DAILY REPORT NO: 010

Site Visit: February 3, 2012 (9:30am to 12:30pm)

Survey Areas: Units 12F, 11F, 10F, 9F, 8F, 7F, 6F, 5F, 4F, 3F, 1F, front entrance, and building exterior. I was unable to gain access to 2F because the floor was in the process of being sanded.

Performance Level: Water cut off valve (hall closet) access.

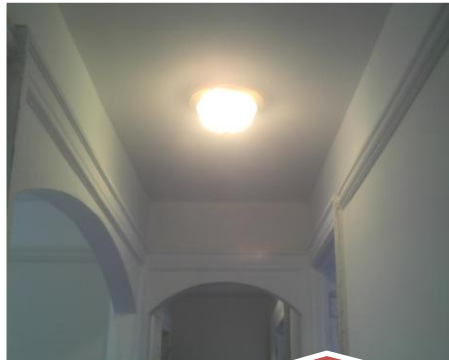
Access panels: I believe it is imperative to install access panels where the water cut off valve is located. Some units currently have spaces cut out for panels and some do not. Vernon (Dellwood) informed me that all units would include panels.

Inadequacies: Bones found littered in the tub 9f

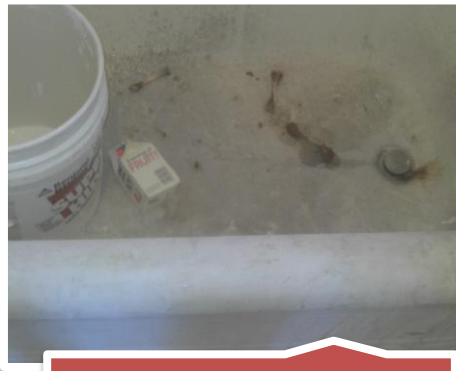
Refuse from workers: Remnants of food were found on the floor and in the bathtub of unit 11F and 10F. Units should be cleaned of this type of debris daily so that it will not attract vermin.
